**City of Richmond**  
Urban Development Division

## General Compliance Request

**File:** DP 04-272603

**Re:** **Application by Chandler Katsura Developments Inc. for a General Compliance at 6333 Katsura Street (formerly 6440 Garden City Road and 9071, 9111, 9131, 9151, 9171, 9191 and 9211 Alberta Road)**

Project:	Garden City, Cook Road, Richmond	Project No.:	04023
Title:	Daycare Hard Landscape	Scale:	1/8" = 1' 0"
		Date:	March 27 2006
		Drawn:	FF
		Sheet:	Daycare L1
		No.:

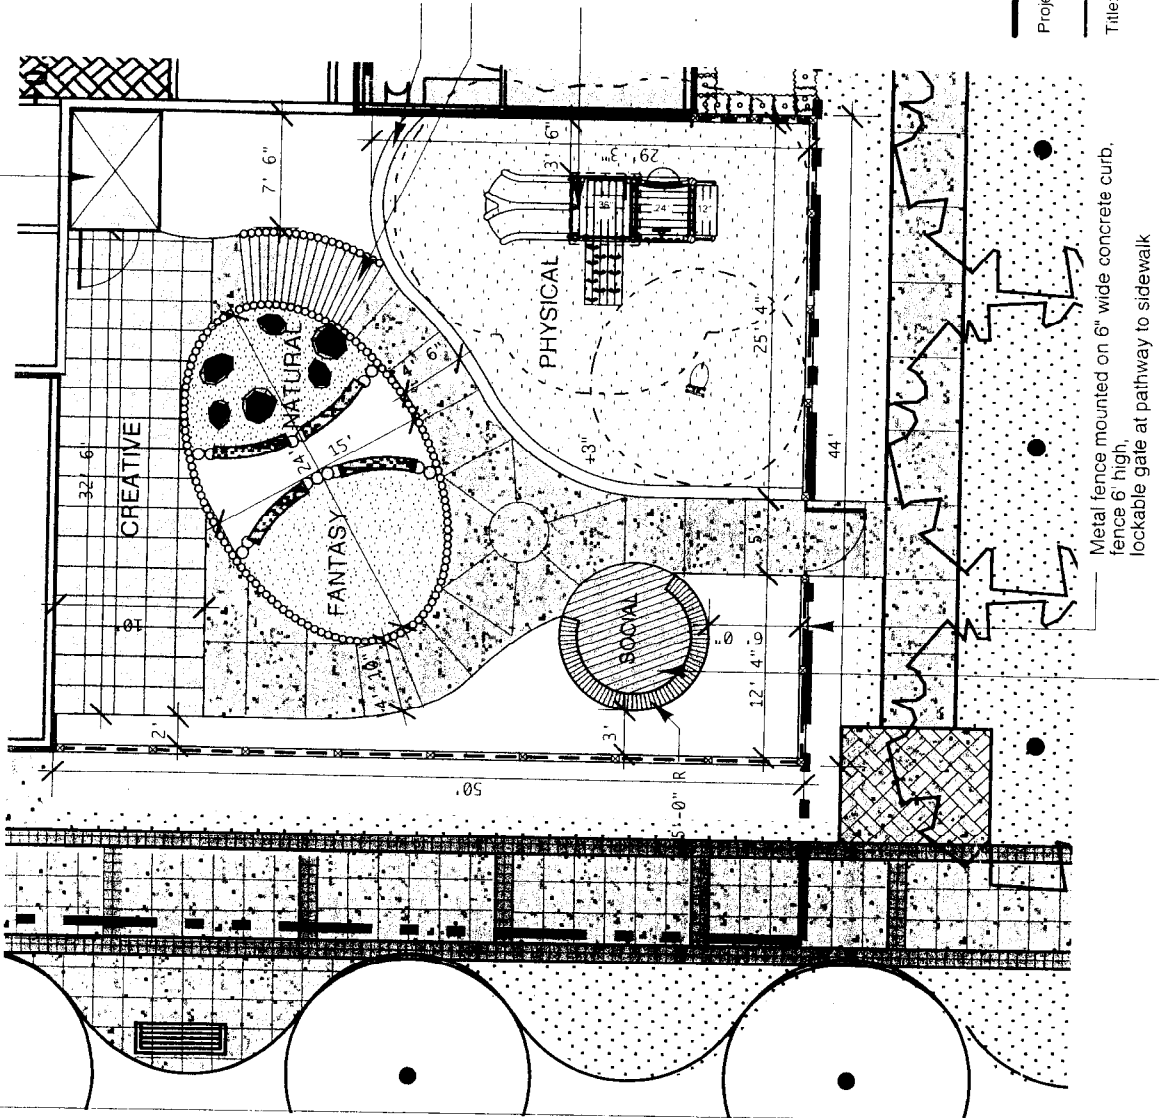
1. Please let me know what the ground cover is for the white area at the building side of the playground.
2. I recommend that the entrance to the "social" area be rotated to prevent clashes with small bike traffic.
3. Is there a back planned for the bench? This might need to be considered to prevent small children jumping and/or falling off.
4. An alternative could be to make the social area contiguous with the ground.
5. Will the river rocks be glued down? We need to think about rocks being picked up and either thrown or placed on the bike path.

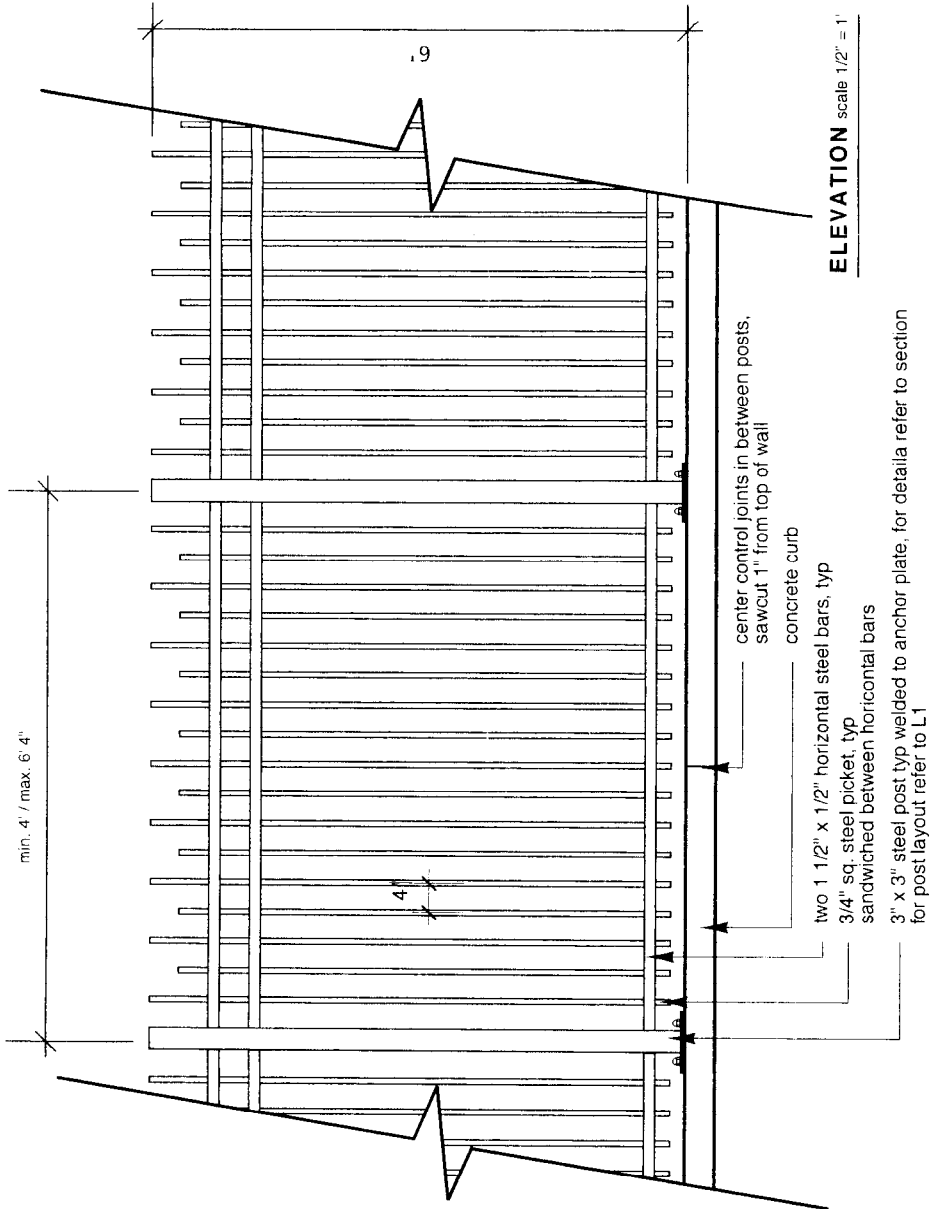
Thank you for the revised playground drawings. This appears to be a well thought out and child friendly area and with a few adjustments I am prepared to accept the drawings at this stage.

Here are my comments:

The playground allows for 25 children. However I will need to have from the licensee a plan as to how he intends to use the area between the two age groups that he is planning to enroll.
